# UNITED STATES PATENT AND TRADEMARK OFFICE

# Office Action Summary

10/550,279

SPAGGIARI, ALESSANDRO

Fig. 1 and Fig. 2 of United States Patent No. 3,303,995 (Boeckel hereinafter)

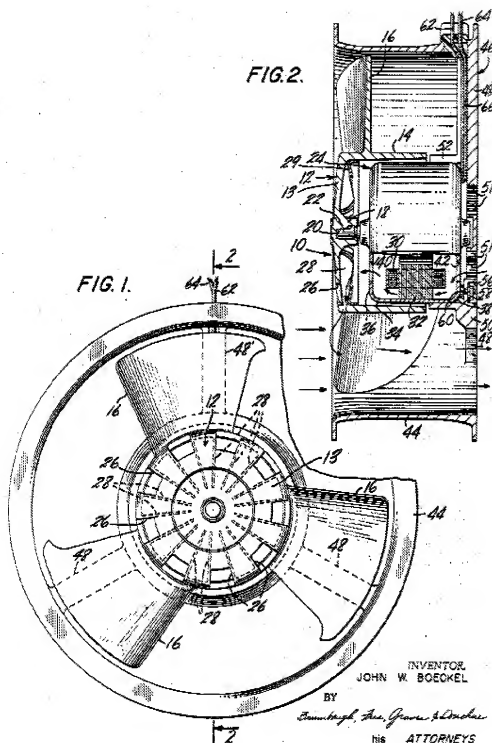
2. Claims 1, 2 and 4-7 are rejected under 35 U.S.C. 102(b) as being anticipated by US PAT 3,303,995 (Boeckel hereinafter)

- In re Claim 1, Boeckel discloses (see Fig.'s 1 and 2 above):

An axial fan in which an impeller comprises a hub (12), motor-powered so that it rotates about its own central axis in a predetermined direction of rotation, and a plurality of blades (16) extending from the hub (12) in directions transversal to the axis; the hub (12) having a cup shape and, being formed by a bottom wall (13) and a ring-shaped side wall (14); the bottom wall (13) having a plurality of long ribs (28) arranged in a radial direction and extending in height towards the hub (12) cavity, each of the ribs (28) abutting on an internal face of the ring-shaped side wall (14) and delimiting, together with said ring-shaped side wall (14), a corner area of the bottom wall (13) positioned in front of the rib (28) with reference to the direction of rotation; the fan being characterised in that each corner area has a through-hole (26) for discharging any debris, in particular water, sand, soil or sludge, from the hub (12) cavity to the outside of the hub (12).

- In re Claim 2 Boeckel discloses (see Fig.'s 1 and 2 above):

The fan according to claim 1, characterised in that the through-holes (26) are evenly distributed along a circle centred on the axis and close to the ring-shaped side wall (14).

- In re Claim 4 Boeckel discloses (see Fig.'s 1 and 2 above):

The fan according to any of the foregoing claims, characterised in that in each of the said corner areas a through-hole (26) is delimited by at least three walls, of which a first wall substantially acts as an extension of the ring-shaped side wall (14).

- In re Claim 5 Boeckel discloses (see Fig.'s 1 and 2 above):

The fan according to any of the foregoing claims, characterised in that in each corner area a through-hole (26) is delimited by at least three walls, of which a second wall substantially acts as an extension of the rib (28).

- In re Claim 6 Boeckel discloses (see Fig.'s 1 and 2 above):

The fan according to any of the foregoing claims, characterised in that, with reference to the direction of the axis and to the direction of rotation of the hub (12), each through-hole (26) is delimited by at least three walls, of which a first flat external wall lies in a plane at a right angle to a radial direction and to the bottom wall (13).

- In re Claim 7 Boeckel discloses (see Fig.'s 1 and 2 above):

The fan according to any of the foregoing claims, characterised in that, with reference to the direction of the axis and to the direction of rotation of the hub (12), each through-hole (26) is delimited by at least three walls, of which a second flat rear wall lies in a plane parallel with a radial direction and is angled backwards by a predetermined angle relative to the direction of the axis.
